# Division 2000: Pavement Systems

**DIVISION 2000 PAVEMENT SYSTEMS****TABLE OF CONTENTS**

STANDARD SPECIFICATION REFERENCE  
305.2  
DATE  
OCT. '04  
STANDARD DRAWING NO.  
2150B

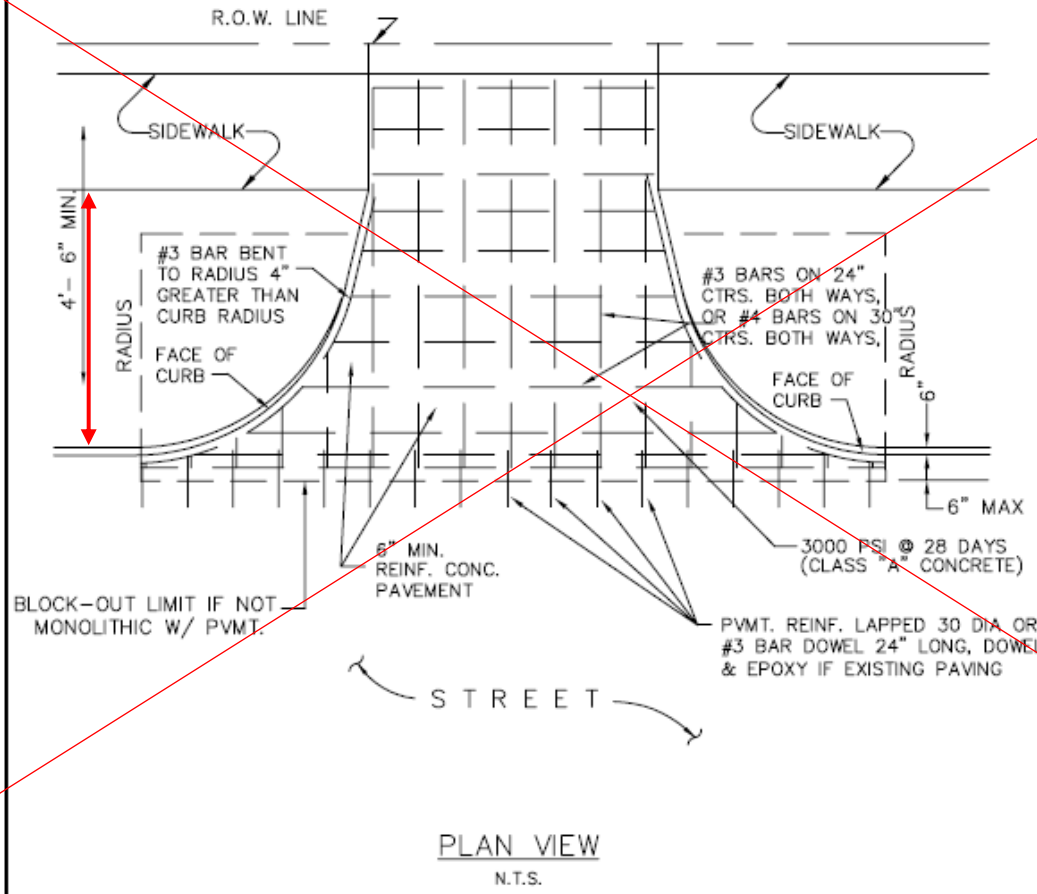
Use  
Arlington  
Drawings for  
residential  
driveway  
approaches

Add cross section view like 2150A

<del>ALLEY</del> APPROACH RADIUS RETURN TYPE	North Central Texas Council of Governments 	STANDARD SPECIFICATION REFERENCE 305.2	
		DATE OCT. '04	STANDARD DRAWING NO. 2160

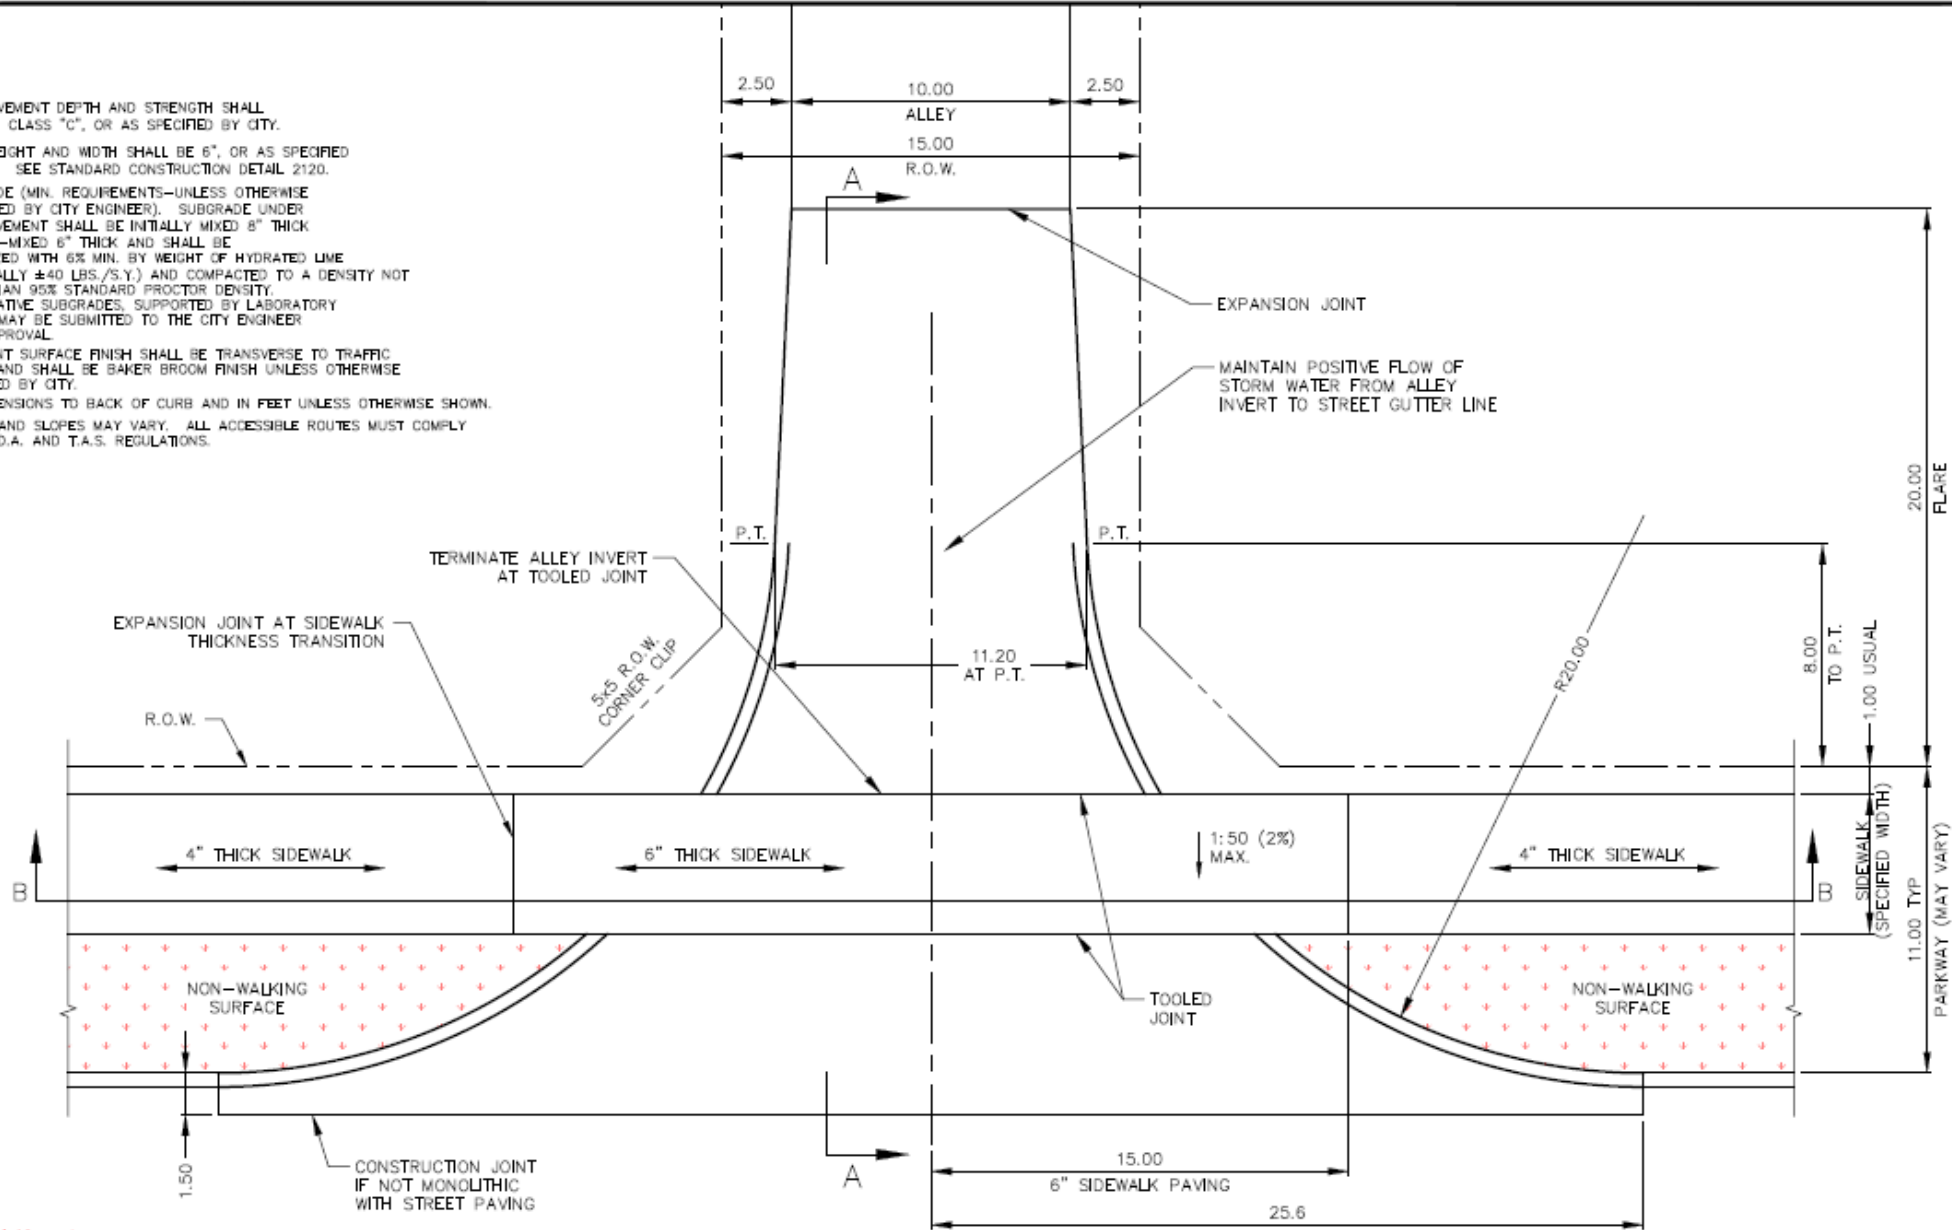
Over 12% grade break is not recommended?

Commercial Driveway

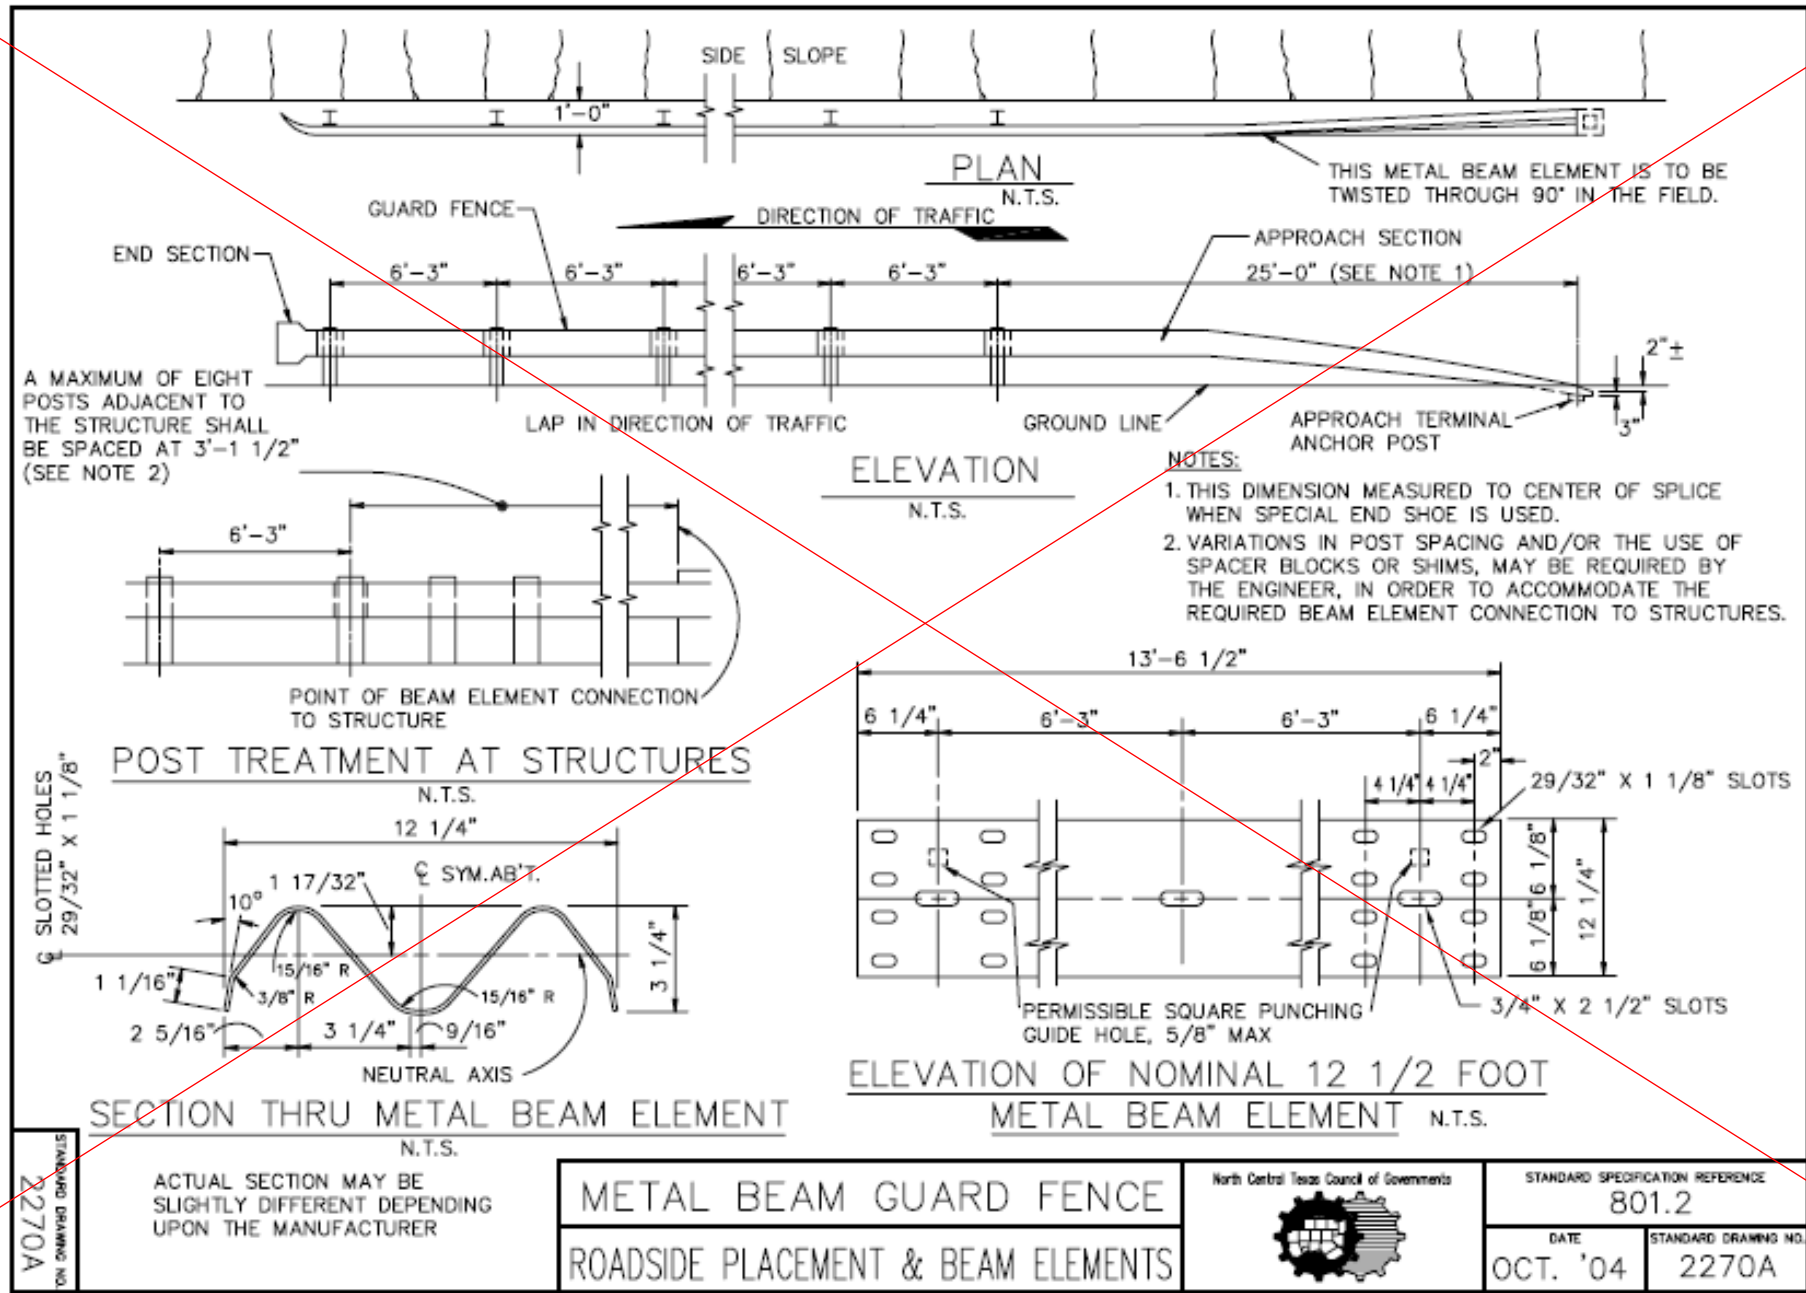
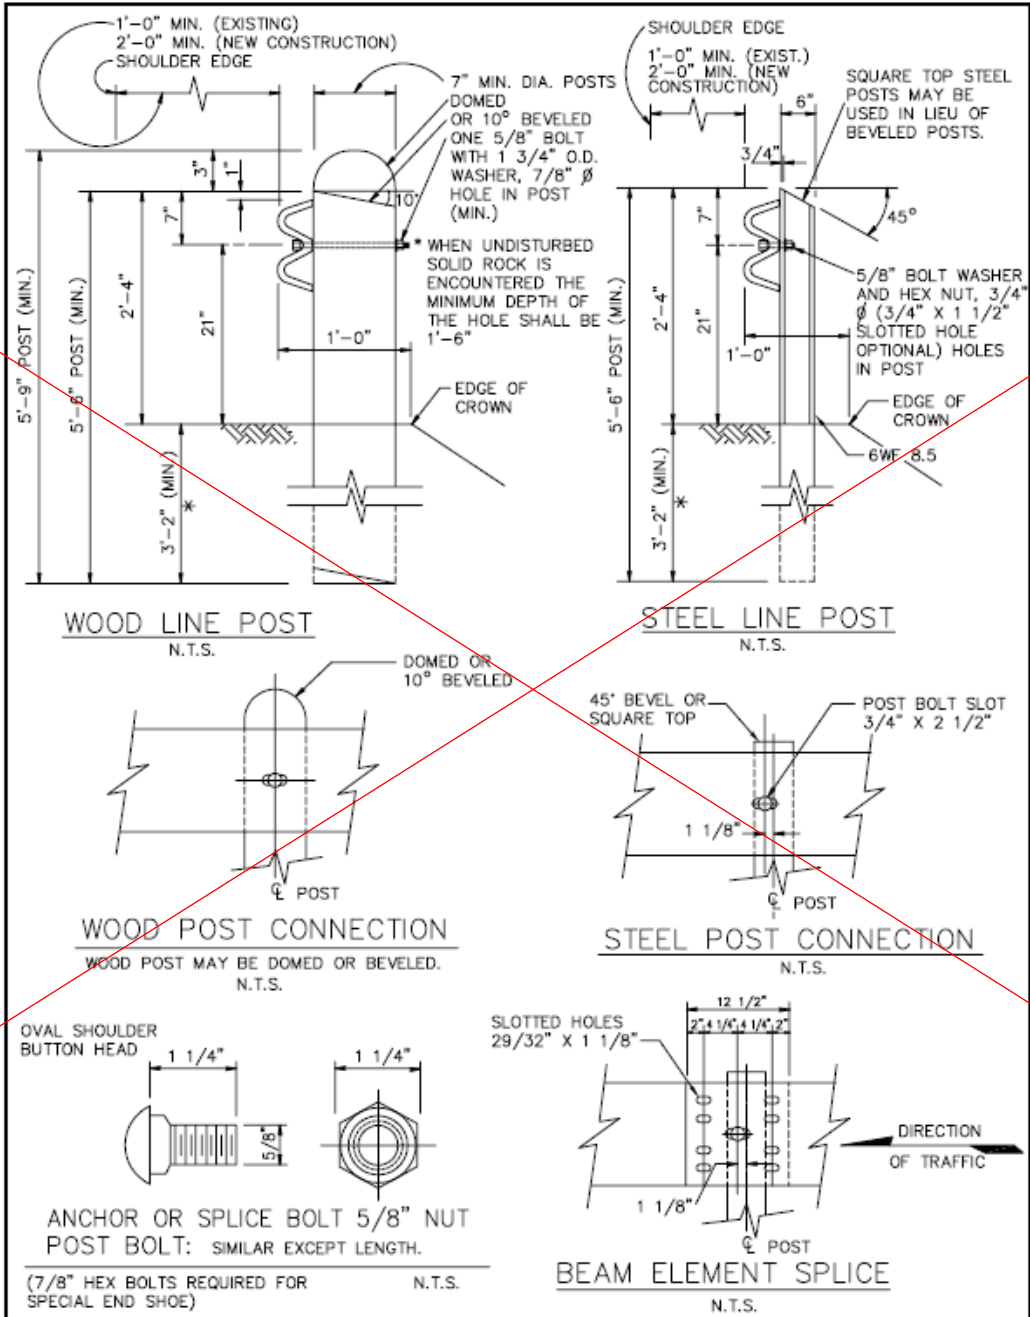
Remove and reference the TxDOT Metal Beam Guard Fence

Remove and  
reference the  
TxDOT Metal  
Beam Guard  
Fence
